# **3 Volt Intel StrataFlash<sup>®</sup> Memory**

## **28F128J3A, 28F640J3A, 28F320J3A**

### **Specification Update**

Order Number: 298130-014

Figure 1. AC Waveform for Standard Word/Byte Read Operations

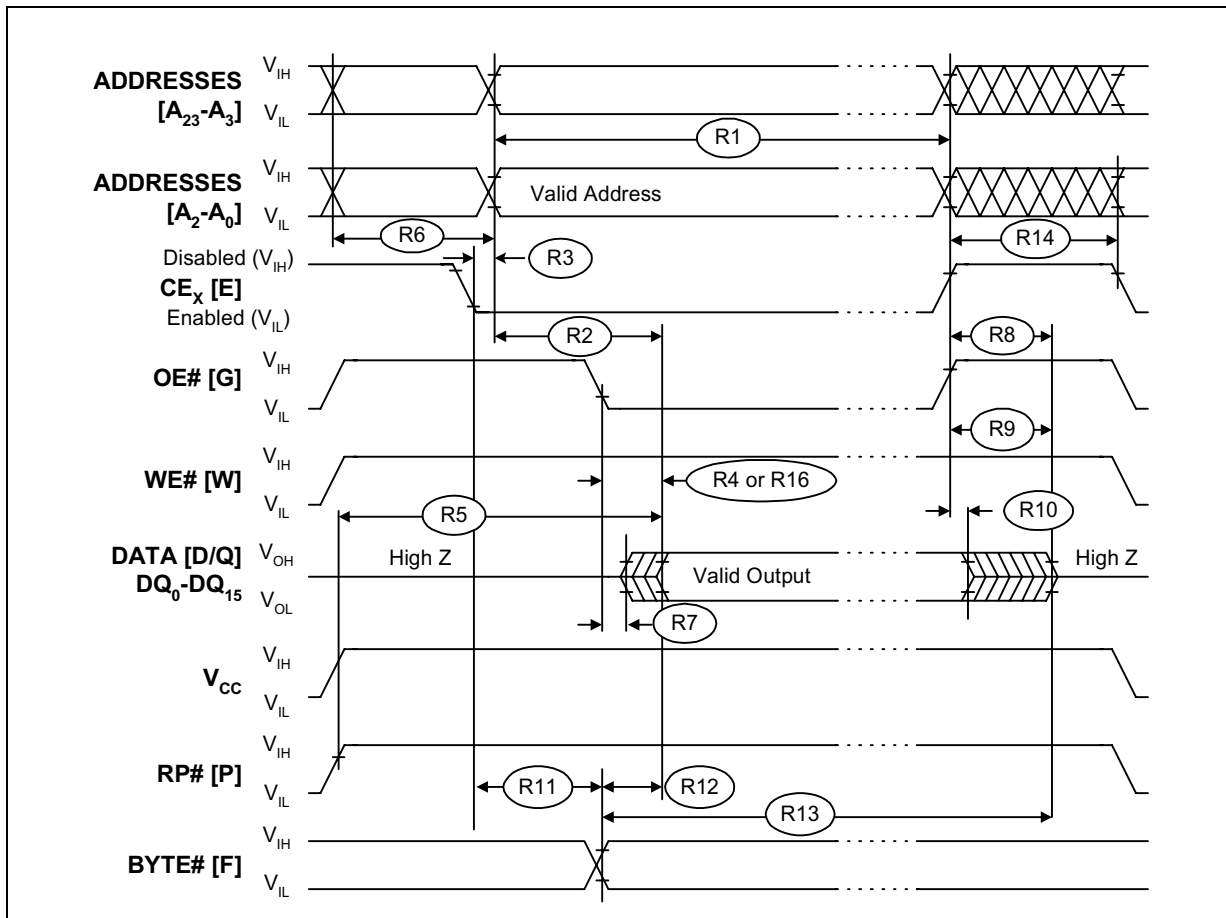
Problem: Devices need the parameter  $t_{ELQX} = 150$  ns minimum. CE low to output in low Z ( $t_{ELQX}$ ) is designated as R6 in Figure 1, in this Specification Update revision.

Problem: Devices need the parameter  $t_{ELAV} = 500$  ns maximum. Chip Enable to Address Valid ( $t_{ELAV}$ ) is designated as R3 in Figure 1, in this Specification Update revision.

Problem: The parameter  $t_{ELQV}$  has been deleted.

The 28F320J3A read parameters  $t_{AVAV}$  (R1),  $t_{AVQV}$  (R2), for 3 V I/O operation have been changed from 90 ns to 100 ns. Customers who designed systems around the 90 ns parameters should be aware of these changes.

Problem: The 28F320J3 read parameters  $t_{AVAV}$  (R1),  $t_{AVQV}$  (R2), and  $t_{ELQV}$  (R3) have been increased from 100 ns to 110 ns. Customers who designed systems around the 100 ns parameters should be aware of these changes.

Issue: Parameter  $t_{EHQZ}$  (R8) has been reduced from 55 ns(max) to 35 ns(max). Customers may now take advantage of this reduced timing.

Issue: Parameter  $t_{APA}$  (R15) has been reduced from 30 ns(max) to 25 ns(max) on the 2.7 V - 3.6 V range. Previously, 25 ns was only granted on the 3.0 V - 3.6 V range. Customers may now take advantage of this reduced timing.

Issue: Parameter  $t_{GLQV}$  (R16) has been reduced from 30 ns(max) to 25 ns(max) on the 2.7 V - 3.6 V range. Previously, 25 ns was only granted on the 3.0 V - 3.6 V range. Customers may now take advantage of this reduced timing.
